## SUNDRY NOTICES AND REPORTS ON WELLS

8. Well Name and No.  
INDIAN BASIN C GAS FEDERAL COM 29. API Well No.  
30-015-3139610. Field and Pool, or Exploratory  
INDIAN BASIN UP PENN11. County or Parish, and State  
EDDY COUNTY, NM

OXY USA WTP LP - Proposed  
Indian Basin C Gas Federal Com #2  
API No. 30-015-31396

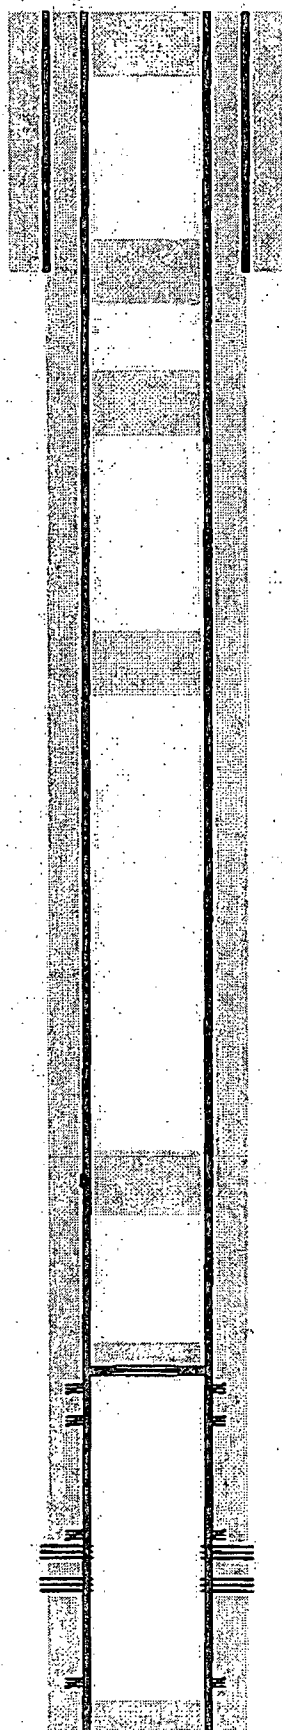
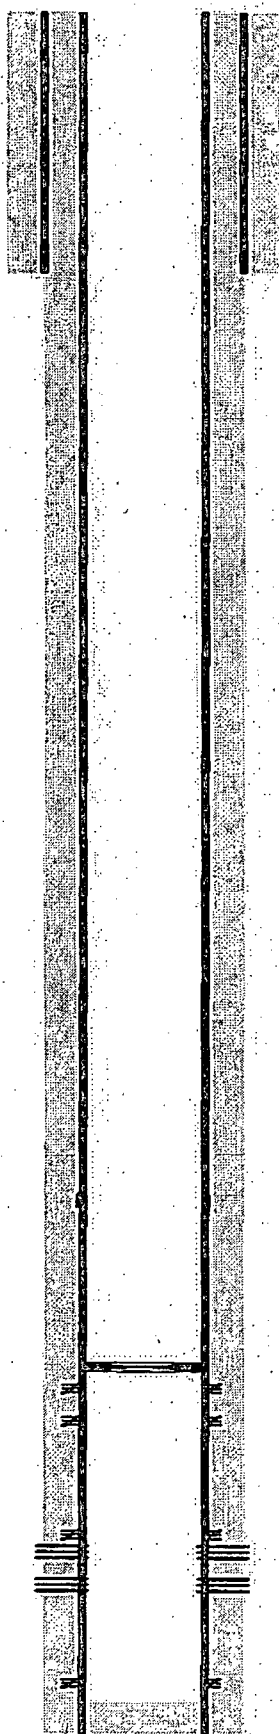
Change: Drill out CIBP @ 6300'.  
Set plug across top stream (170')  
7553-7383. WOC Tag.  
Set CIBP @ 6948. Cap w/ 25sx.  
Set CIBP @ 6300. Cap w/ 25sx.  
Add plug  
5900-5750. (T/WC)
